# Authors' Response: Minimum Confinement Reinforcement for Prestressed Concrete Piles and a Rational Seismic Design Framework

This article is published as Sritharan, S., Fanous, A., Huang, J., Suleiman, M., and Arulmoli, K. 2016. Authors' Response: Minimum Confinement Reinforcement for Prestressed Concrete Piles and a Rational Seismic Design Framework. *PCI Journal* 61(3): 107-109. Posted with permission.

FIGURE 2.

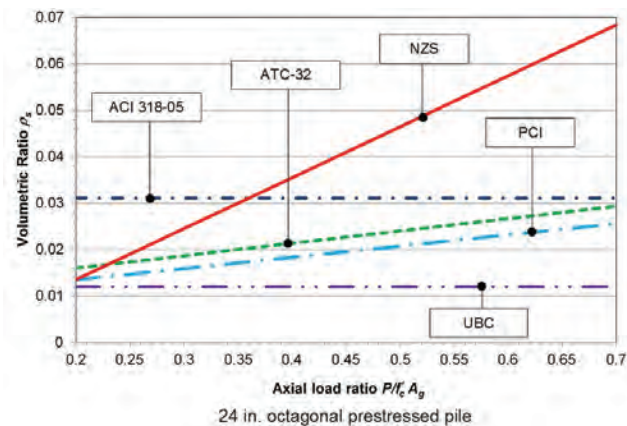
The *Uniform Building Code* requirements<sup>5</sup> shown in the paper must have a misprint because it says that the minimum spiral steel ratio is 0.021 for all sizes. **Figure 2** shows 0.021 for the 14 in. (360 mm) square pile and a smaller value, perhaps 0.012, for the 24 in. (610 mm) octagonal pile.

- The variable  $\phi$  in Eq. (5) of the manuscript defines the strength reduction factor; a value of 1.0 was used when finding the confinement reinforcement quantities for comparison with those obtained from other recommended equations.<sup>1</sup>
- For a detailed description of Eq. (5), the reader is referred to NZS 3101.<sup>11,12</sup>
- The UBC requirements should read as follows:  $\rho_s \geq 0.021$  for piles 14 in. (360 mm) and smaller; and  $\rho_s \geq 0.012$  for piles 24 in. (610 mm) and larger.<sup>13</sup>
